## STAFF RECOMMENDATION

1231 Sixth Avenue North

December 19, 2018

**Application:** Partial Demolition; Alterations; New construction—Addition

Figure 3. 1908 Sanborn Map

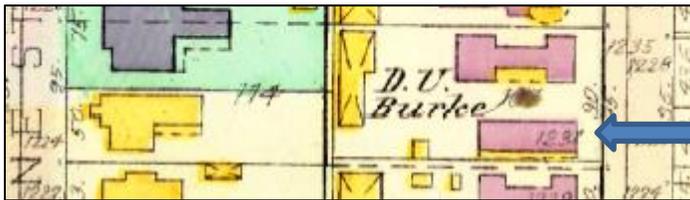
The house has been altered over the last century and a half. The existing front porch and front window opening are not original, although they are extant in the earliest photo of the house found from 1979 (Figure 2). The Sanborn maps from 1908 until 1957 show that the house previously had a small covered stoop over the entry door and illustrate how the frame side-portions of the house have changed over the years (Figures 3, 4, 5).

Figure 5. 1957 Sanborn Map

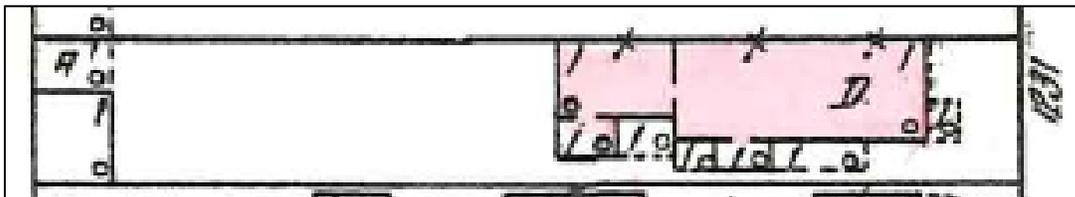
The applicant is also planning to alter the front porch columns. The existing front porch is not original to the house, as it does not appear on any of the Sanborn maps from 1908 to 1957. The 1970s photo shows that the porch columns were wrought iron previously, but have since been changed to wood columns. The applicant will add capitols and bases to the existing columns. Staff finds this to be appropriate, as historically porch columns had caps and bases.

① ARCHITECTURAL SITE PLAN -PROPOSED  
1/16" = 1'-0"

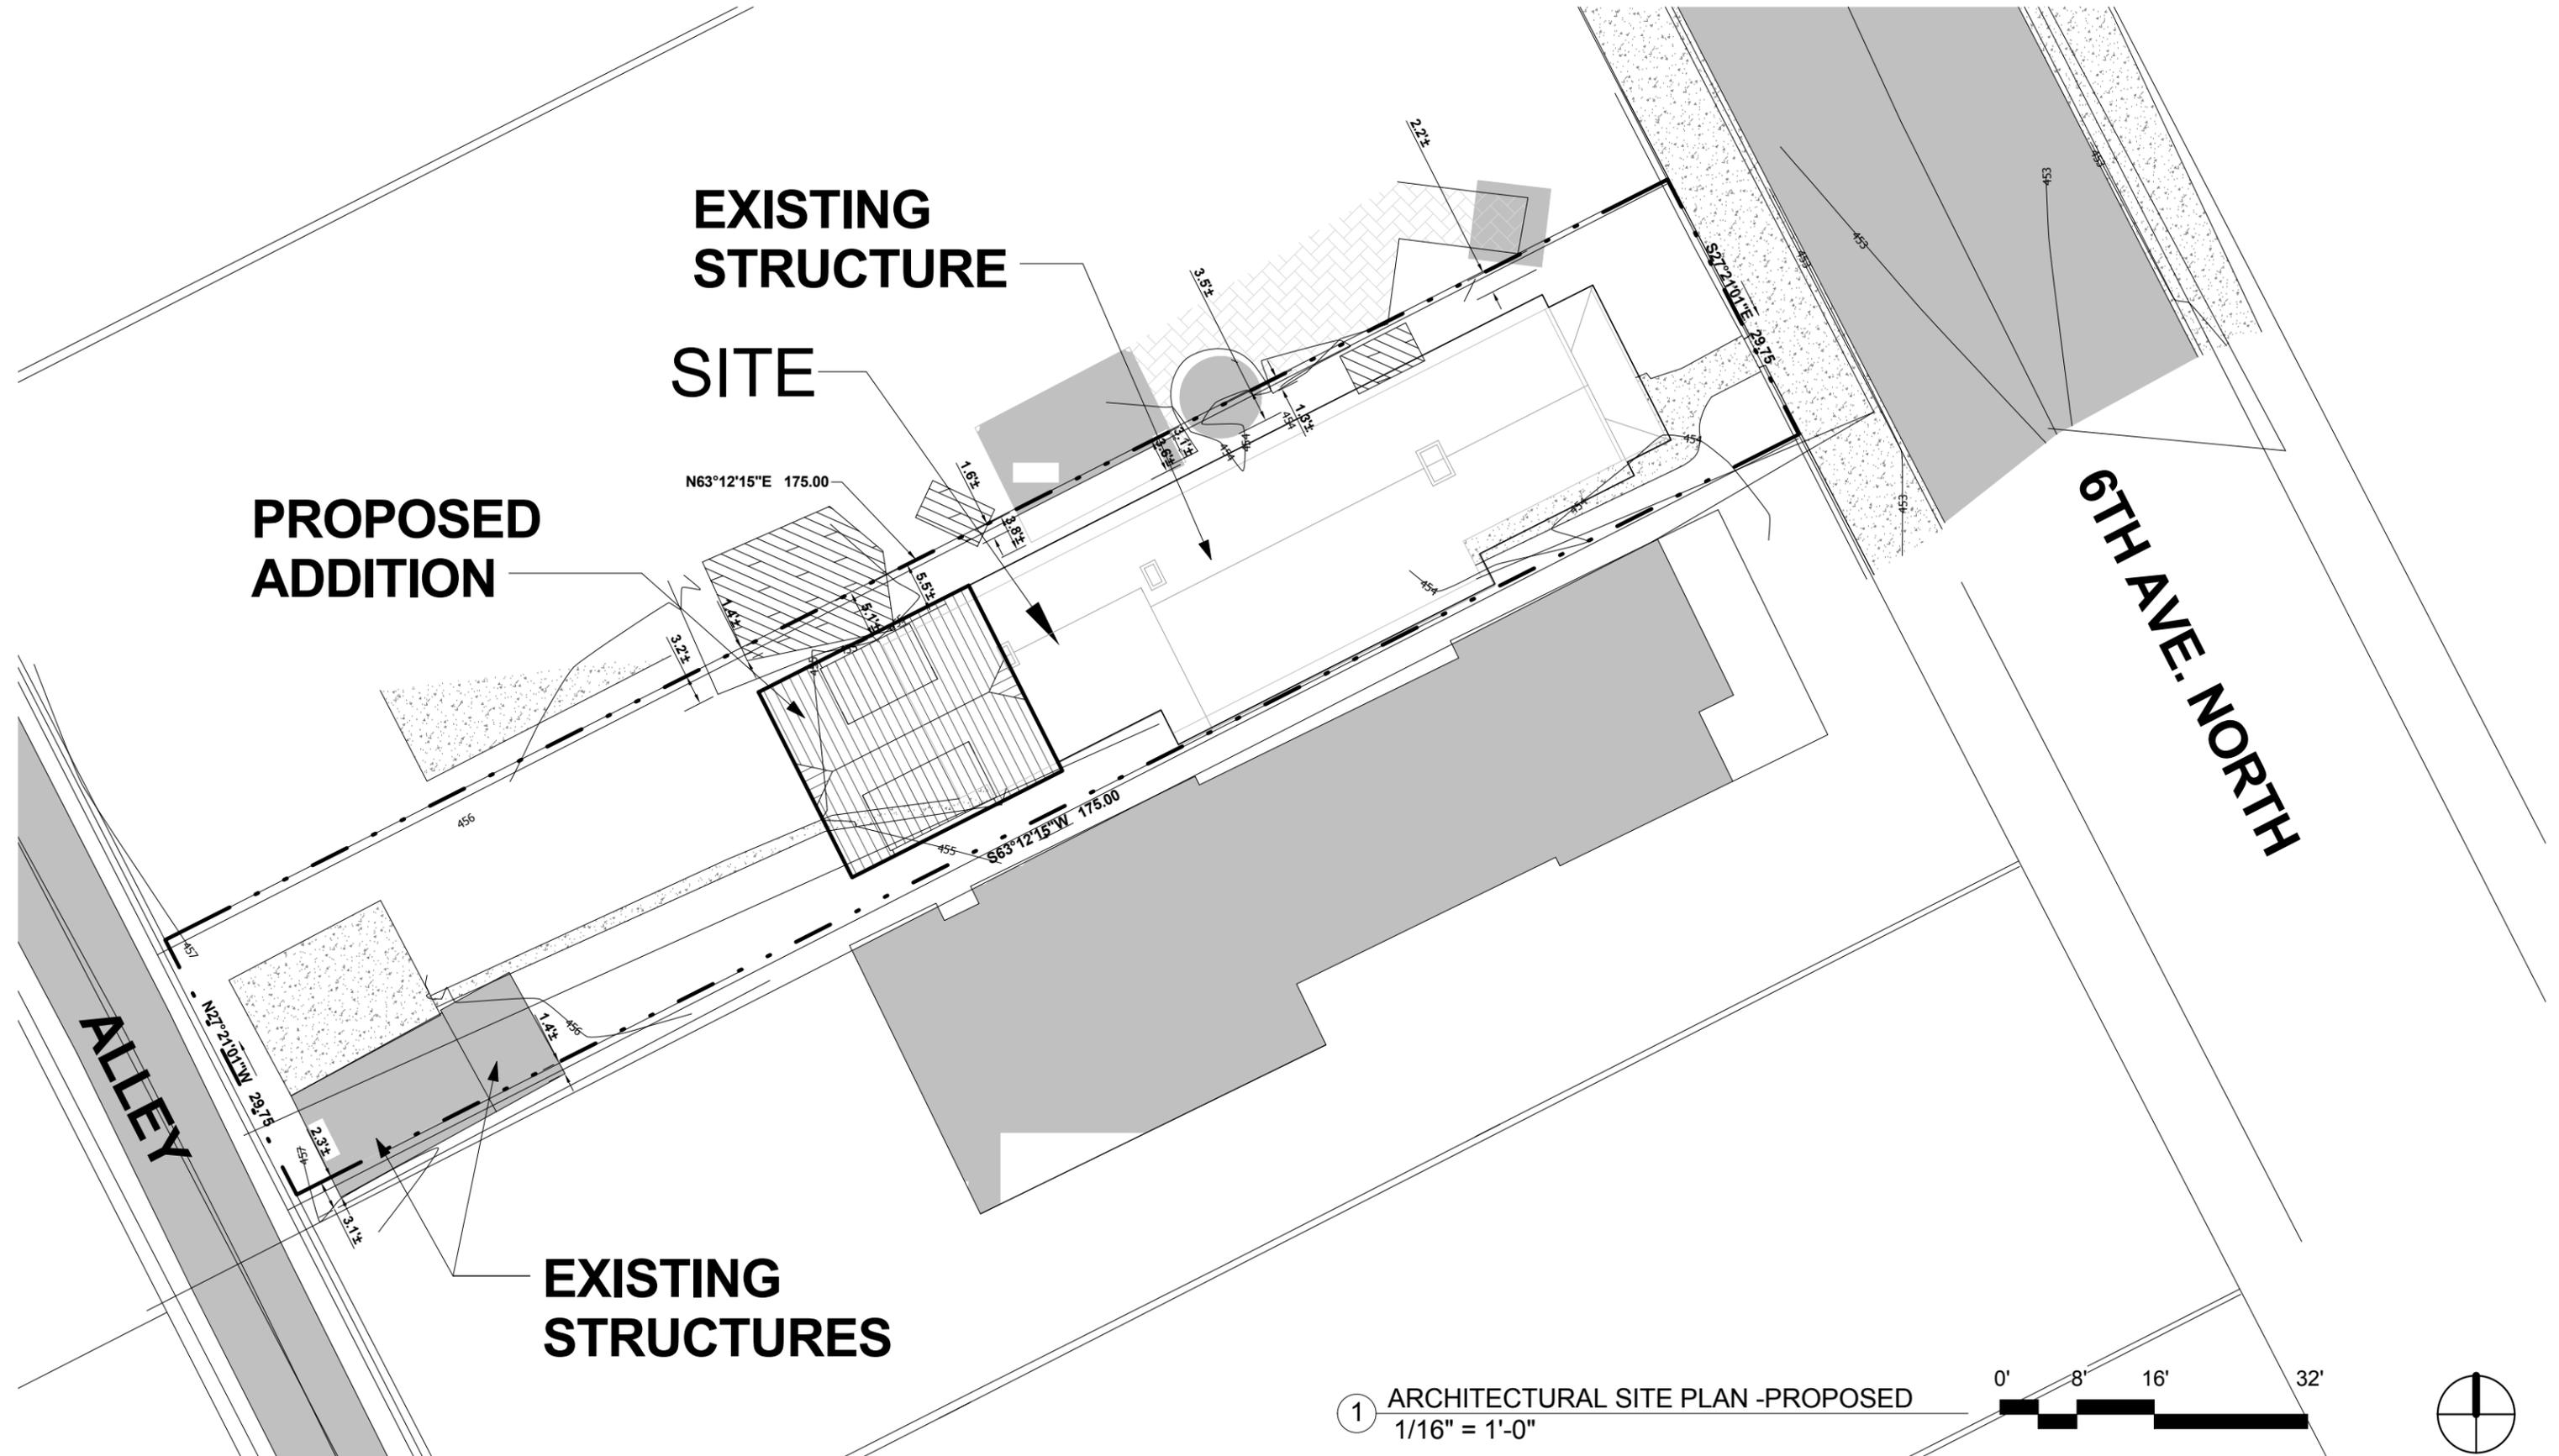
Placement: The addition is situated at the rear, which is appropriate. As mentioned under "Addition Massing, Height, and Scale," the addition is not inset from the back walls of the brick house, but that lack of inset is appropriate given the change in material and overall size of the historic house, lot, and proposed addition. Staff finds that the proposed addition meets Section V.3. of the design guidelines.

Utilities/Mechanicals. The applicant did not indicate on the plans the proposed location of the HVAC units and other utilities. Staff recommends approval of their locations in order to ensure that the project meets Sections III.E.10. and V. of the design guidelines.

Project #: 0000  
Date: 12-1-2018  
DEMO SHEET

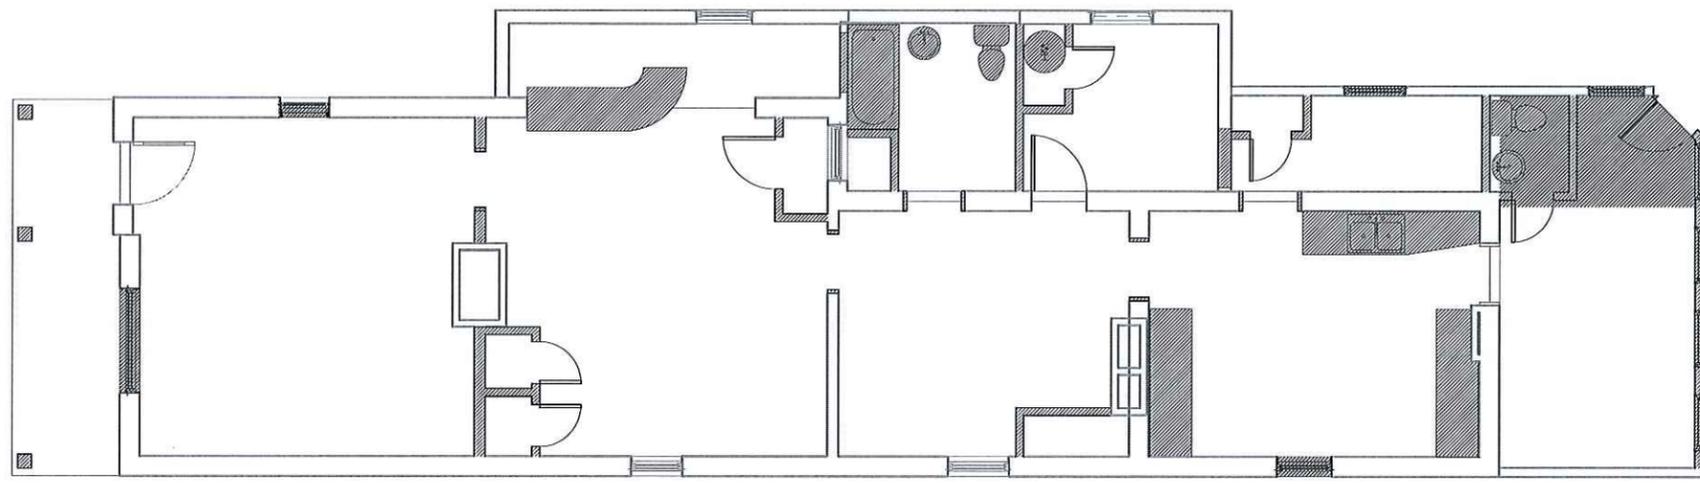
Partial Demolition. The applicant proposes to demolish frame portions of the house at the back of the house (Figures 6 & 7). The roof will be removed, and this part of the house will be reconstructed and reworked in the new addition. This part of the house was likely constructed after 1957, as the 1957 Sanborn map does not show any frame elements behind the brick back wall (See Figure 5). The addition's date of construction, materials, and condition do no relate to the historic character of the house. Staff therefore finds that its partial demolition meets Section VII.B.2. for appropriate demolition and does not meet Section VII.B.1. for inappropriate demolition.
